Work Order ID 135102

Item Name: Crosstube Turning Detail

DRAWING NO. D206-667-141	TITLE CROSSTUBE ASS'Y (206B HIGH FWD)	REV. C	DART AEROSPACE LTD ENGINEERING ORDER		D.E.O. NO. D206-667-141-C-1	SHEET NO. SHEET 1 OF 1	SCALE NTS
DRAWN <i>q</i>	CHECKED <i>ASS</i>	MFG. APPR. <i>JD</i>	APPROVED <i>WD</i>		DE APPR. <i>JA</i>		
DATE 11.07.15	DATE 11.07.20	DATE 11.07.21	DATE 11/07/21		DATE 11.07.21

DRAWING NO. D206-667-141		TITLE CROSSTUBE ASS'Y (206B HIGH FWD)		REV. C	DART AEROSPACE LTD ENGINEERING ORDER		D.E.O. NO. D206-667-141-C-2	SHEET NO. SHEET 1 OF 1	SCALE NTS
DRAWN AJS		CHECKED <i>[Signature]</i>		MFG. APPR. <i>[Signature]</i>		APPROVED <i>[Signature]</i>		DE APPR. <i>[Signature]</i>	
DATE 12.08.02		DATE 12.08.02		DATE 12.08.02		DATE 12.08.02		DATE 12.08.02

DETAIL P
BONDING STRAP INSTALLATION 2 PL

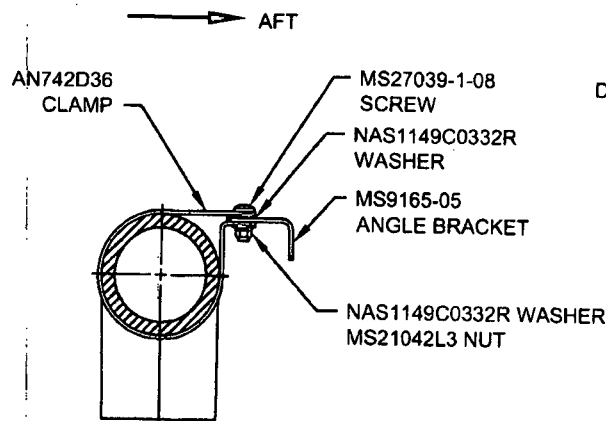
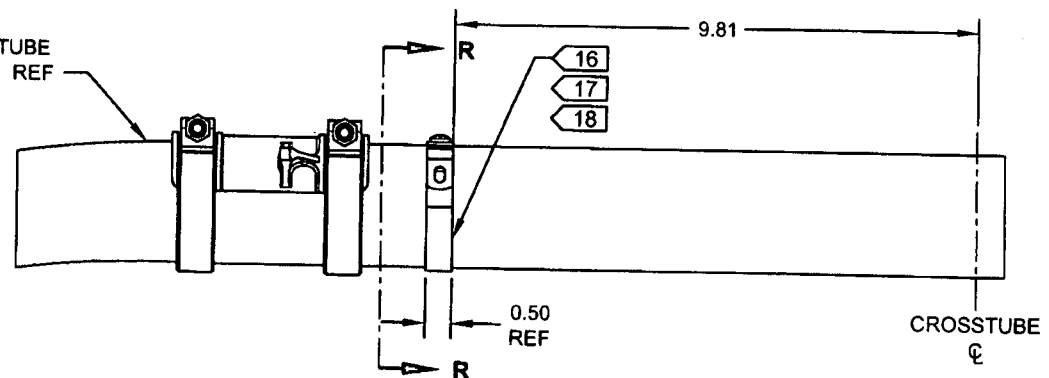
ADD ELECTRICAL GROUNDING STRAP

- 16) MASK AREA UNDER CLAMP PRIOR TO PAINTING
- 17) SEAL EDGES WHERE AN742D36 CLAMP MEETS WITH THE CROSSTUBE USING SIKAFLEX-241/-291 OR MIL-S-8802 CLASS B2 OR PROSEAL 890 SEALANT
- 18) PERFORM RESISTANCE CHECK TO ENSURE MAX RESISTANCE IS 10 MILLIOHMS
